STREET LIGHTING LAYOUT

PROJECT NAME: BRATTLEBORO	PLOT DATE: 06-FEB-2003
PROJECT NUMBER: BHF 2000 (17)	DRAWN BY: G. ROY
FILE NAME: 94J078\Structures\sj078a17	CHECKED BY: T. SUMNER
PROJECT MANAGER: R. R. WHITCOMB	SHEET 30 OF 71
DESIGNED BY: G. ROY

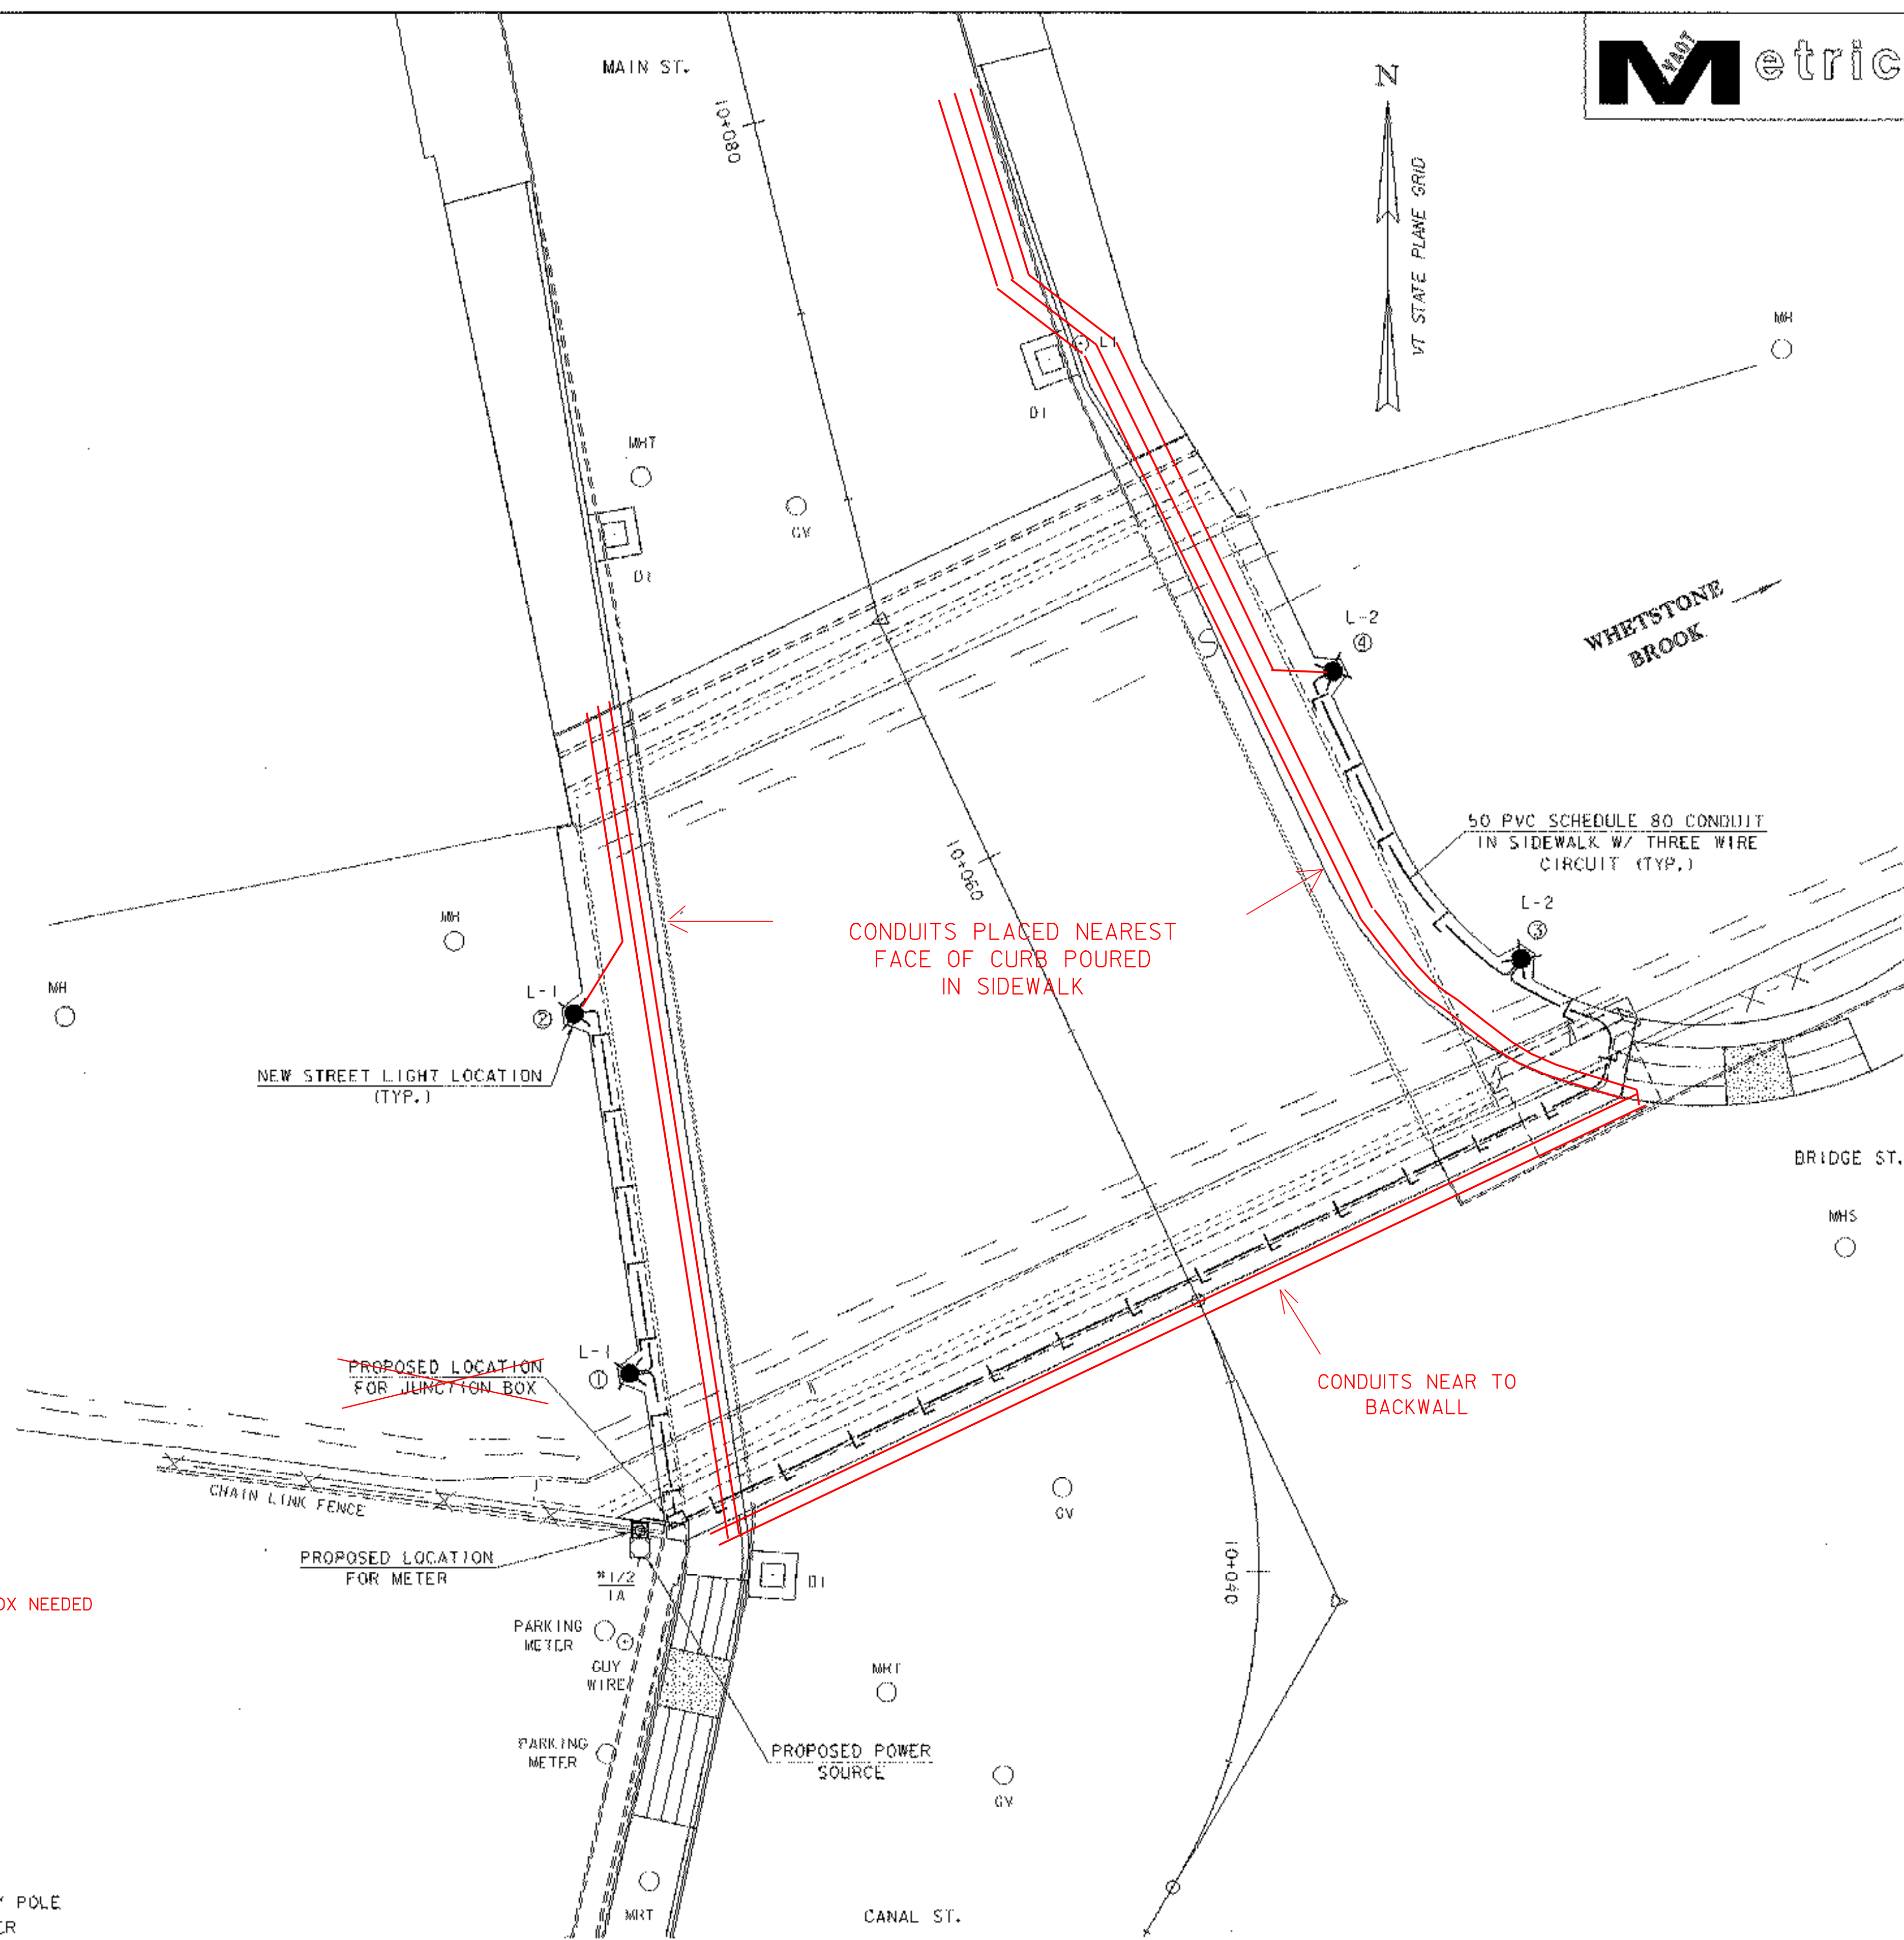
- ONE PHOTOCELL FOR THE LIGHTING CIRCUIT SHALL BE LOCATED AT THE POWER SOURCE OR SOME COMMON POINT, AS DIRECTED BY THE ENGINEER. **ONE PHOTO CELL ON EACH POST**

- COORDINATE ALL ITEMS REGARDING PROJECT POWER WITH THE TOWN OF BRATTLEBORO BEFORE COMMENCING WORK.
- INSTALL ALL LIGHT POLES, LUMINAIRES, WIRING AND DISCONNECT PLUG KITS.
- INSTALL ALL JUNCTION BOXES, THE CONDUIT, PHOTOCELL AND WIRING AS DETAILED ON PLAN DRAWINGS. **NO JUNCTION BOX NEEDED**
- INSTALL POWER DROP STANCHION, ~~OPTION #3~~ SEE STD. E-175M ON EXISTING POLE
- INSTALL REMOTE TWO RELAYS WITH CIRCUIT BREAKERS FOR AUTOMATIC SWITCHING OF THE TWO LIGHTING CIRCUITS.
- THE CONTRACTOR IS DIRECTED TO SECTION 679.09 REGARDING POWER COSTS FOR THE STREET LIGHTING.
